Bath Clean Air Plan

Bath and North East Somerset Council

Consultation Response Report

674726.BR.042.OBC-25b | 1

Figure 3.2 – Revised Class D CAZ boundary, following consultation

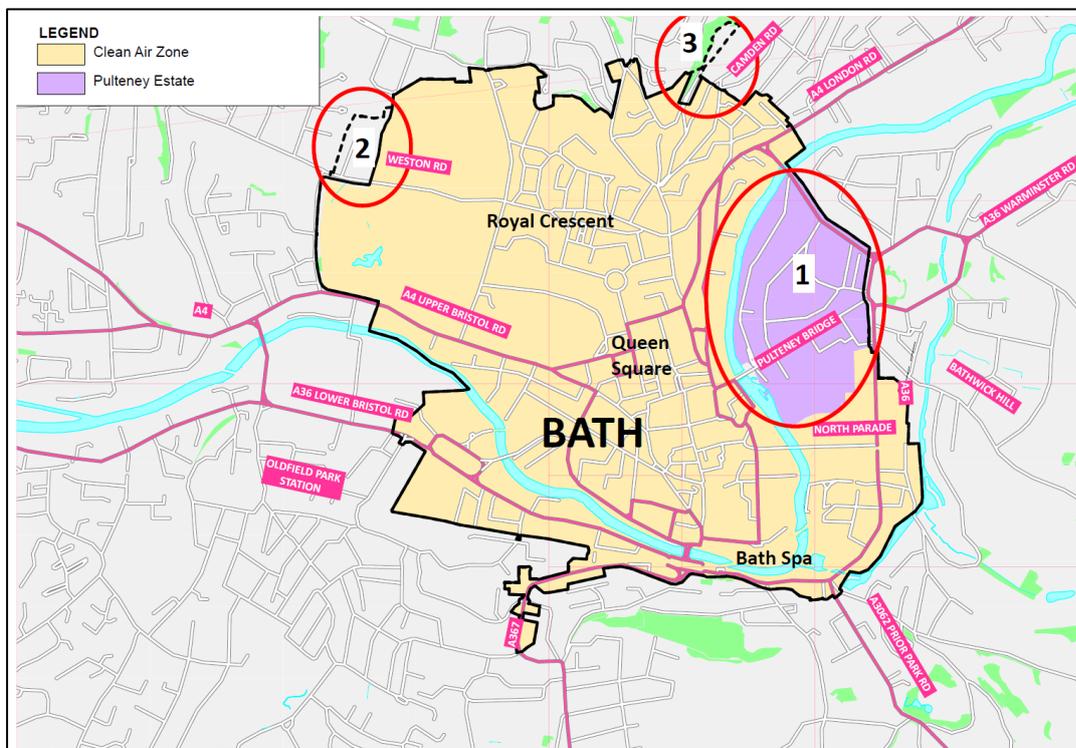
Streets suggested for exclusion from the zone via minor amendment to proposed Class D zone boundary	Notes on feasibility/issues to consider
<p>Pulteney Gardens, Pulteney Grove, Pulteney Avenue, Lime Grove, Lime Grove Gardens</p>	<p>These roads were included in the boundary that went out for consultation due to a late boundary amendment to move the cordon point on the A36 back from Widcombe to a point just south of Bathwick Roundabout. This was to make signing easier and to provide safer, more suitable 'escape' routes to allow re-routing choice 'at the cordon' position. In particular:</p> <ul style="list-style-type: none"> • The entrance to the CAZ is now clearly signed at Bathwick Hill Roundabout; this will allow all vehicles, particularly HGVs, to use Bathwick Hill or the A36 North (via a 'U' turn or using Vane Street) to exit the roundabout and avoid entering the zone; • The proposed signage before the canal will also make it clear to non-compliant LGVs and cars that crossing the canal bridge will result in entry into the CAZ. Vehicles are able to re-route at this point using either Horseshoe Walk or Abbey View; and • As proposed at consultation stage the boundary avoids issues with non-compliant vehicles routing past Widcombe Primary School to turn, or 'entrapment' issues with HGVs forced to enter if reaching Widcombe. <p>Excluding these roads would require new cordon points at the Lime Grove, Pulteney Gardens and Pulteney Avenue minor road junctions with the A36, as opposed to a single cordon point on Pulteney Gardens to the east at the canal bridge. Options for turning in these roads, which have significant on-street parking, are limited without reversing back. The proposed boundary location offers better facility for this for non-compliant vehicles.</p> <p>An amendment here is not proposed for this reason.</p>

<p>Cranhill Road</p>	<p>Cranhill Road could be omitted from the CAZ without issue. There would be an increase in ducting/cabling costs although not significant. Its inclusion in the published consultation scheme boundary simply enabled the Weston Road cordon point to be defined just east of the Weston Road/Park Lane mini-roundabout. If removed, Cranhill Road may become more prone to vehicles turning around within it or dropping off passengers outside the CAZ, but this risk is considered low.</p> <p>This amendment is included in the revised Class D CAZ boundary.</p>

<p>St Stephen's Road, Rivers Road, Bella Vista Road, Mount Road, Lansdown Grove</p>	<p>The necessity for including this set of residential roads was the desired inclusion of the Lansdown Road/Richmond Road junction (see above). Most of this area could be excluded by moving the cordon here southwards and establishing revised cordon points as follows:</p> <ul style="list-style-type: none"> • Lansdown Road: just south of the junction with Lansdown Grove; and • St Stephen's Road: just south of the junction with Mount Road. <p>This change would remove the need for the cordon sites at the Lansdown Road/Richmond Road junction, or the alternative suggested earlier. It would also remove the need for bespoke cordon points at the Lansdown Crescent and Upper Lansdown Mews junctions with Lansdown Road. Making this change would not open-up any new opportunity for zone avoidance 'rat-running'. It would also reduce the need for ANPR camera coverage and have no impact in achieving compliance.</p> <p>At this stage, given the desire previously expressed for the Lansdown Road/Richmond Road junction to remain in the zone, an amendment here is not proposed.</p> <p>However, a minor amendment to the proposed boundary is carried forward to remove Rivers Road. This amendment is made following feedback from residents.</p>

The boundary of the proposed Class D CAZ has been amended as shown in Figure 3.2, based on consideration of the consultation feedback (as detailed above) and technical review. This differs from the consultation version by:

- Including the Pulteney Estate area (Area 1 in Figure 3.2);
- Excluding Rivers Road (Area 3 in Figure 3.2); and
- Excluding Cranhill Road (Area 2 in Figure 3.2).

Figure 3.3 – Other possible boundary amendments under technical review

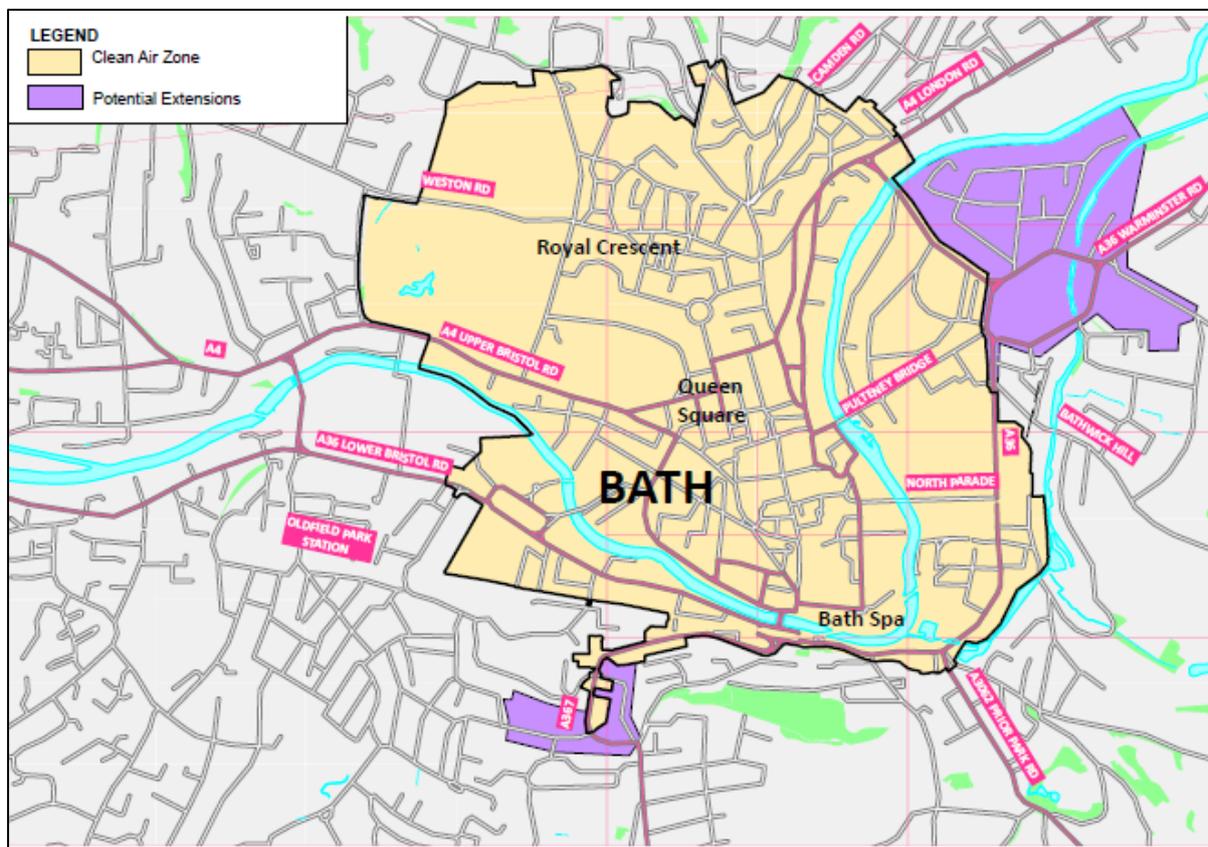
Additionally, other possible amendments highlighted in Figure 3.3, remain under technical review.

Figure 2.1 Reduced Clean Air Zone (CAZ) Extent - Removing the A36 and the A4/Cleveland Place Junction

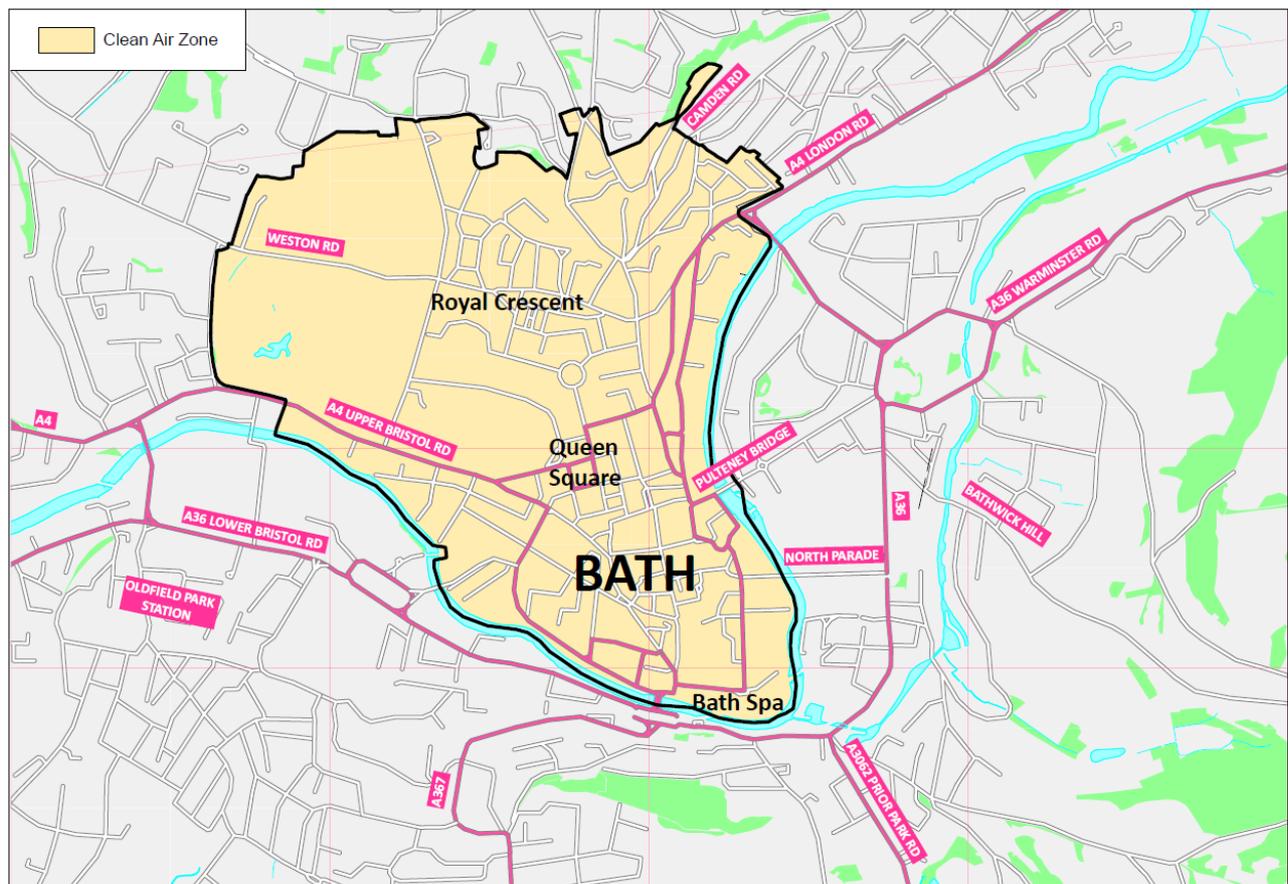
A common suggestion was that the A36 and A4 should be excluded from the zone as these are through routes used by traffic moving through and around Bath. In response to this feedback, additional traffic and air quality modelling work was undertaken to examine the extent to which compliance with the required air quality targets could be delivered with a smaller zone as shown in Figure 3.1. This removed all sections of the A36 and the A4 London Road/Cleveland Place junction from the zone.

Figure 2.1 below shows the reduction to the CAZ specifically tested in this scenario. The whole of the A36 corridor presently included between the Brougham Hayes junction and Bathwick Roundabout is removed. This also removes the included northern part of the A367 Wells Road between Oldfield Road and Churchill Gyratory where, as noted earlier, there is an existing air quality exceedance. To the north of the A36 Pines Way, the Sainsbury's store and other developments served off Ivo Peters Road are also removed from the zone, which would otherwise require a new CAZ cordon point to be established here.

It is accepted that 'tucking in' the zone to the south, so maintaining the A36 route through Bath 'outside' of the CAZ, would assist in addressing 'rat-running' or 'avoidance' concerns, particularly to residents in Upper Oldfield Park/Oldfield Park. The original small CAZ considered at 'Strategic Outline Business Case (SOBC) Stage included just the A36/A367 Churchill Gyratory, but this still severed the east-west A36 route and the A367 radial route into/out of Bath to the south. As a result, the extent of the A36 included in the CAZ was necessarily increased to cover the potential 'rat-runs' via the White Hart junction (Widcombe) and the B Class route between the A367 and the A36/Brougham Hayes junction (Oldfield Park). As a result, it presently now encompasses Sainsbury's, the filling station in this location and the Esso filling station on the A36 Lower Bristol Road just west of the Churchill Gyratory. To the north of Widcombe, the A36 Pulteney Road was included to prevent non-compliant vehicles from using unsuitable roads to turn around and avoid zone entry, with 'U' turns possible at Bathwick Roundabout for all vehicles, including HGV's.
